From: Allie Dunn
Sent: Thursday, 12 June 2025 9:11 am
To: [REDACTED]
Subject: Response to request for consent decision documents
Attachments: LGOIMA - Consents_Redacted.pdf

I refer to your official information request dated 20 May 2025 for information on reasons for declining specific consent applications.

Consent 2: 202.2023.134.1 (34 Burgoyne Street Woodville): we have included the decision below and attached the email, this is a long email chain and only what is listed below is relevant to the decision. **Note this consent has no payment received**

Tararua District	House Relocation with minor recession plane encroachment	Lot: 2 DP: 23847
------------------	--	------------------

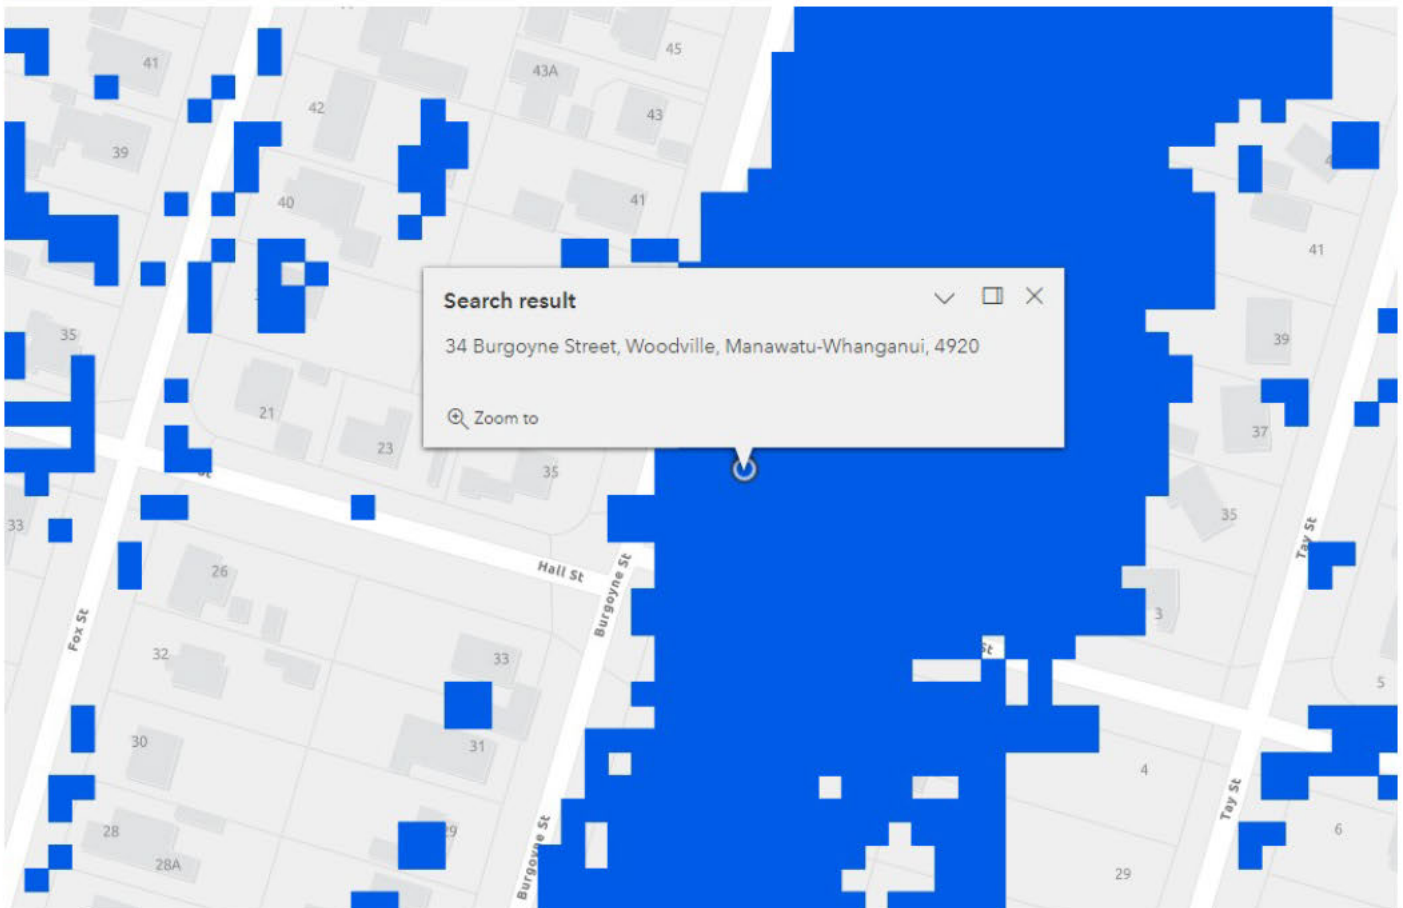
The Natural Hazard Area (Flooding) Standard (below) require this is be avoided or mitigated. As the modelling cover the entire site it will not be able to be avoided an therefore will require mitigation.

Please provide a FFL for the dwelling that complies with the above Standard and is supported by an assessment of the height of the 0.5% AEP (1 in 200 year) flood hazard.

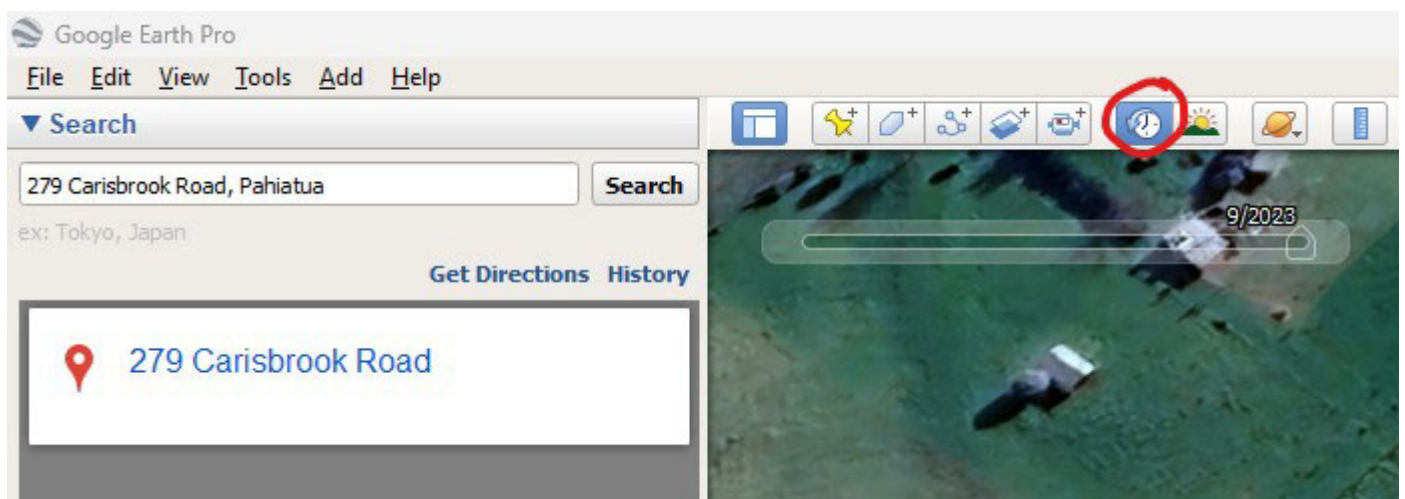
In addition, to issue the certificate, I would also expect to see details of the operation as it is now describing what is present on site, the area covered (which would include the new shed), the specifics of what occurs on site, employees, vehicle movements and equipment. A comparison should then be made to show that the character, intensity and scale between the above and how it is now, has not changed.

As part of my initial review, I have looked at aerial photos on google earth. The first photo below shows the site in December 2003, with the second showing the site 20 years later in March 2023. In my opinion the character and intensity of the site itself, has increased between these two images with large areas of development on the northern portion of the site (I have also included a snip of how I do this on google earth)
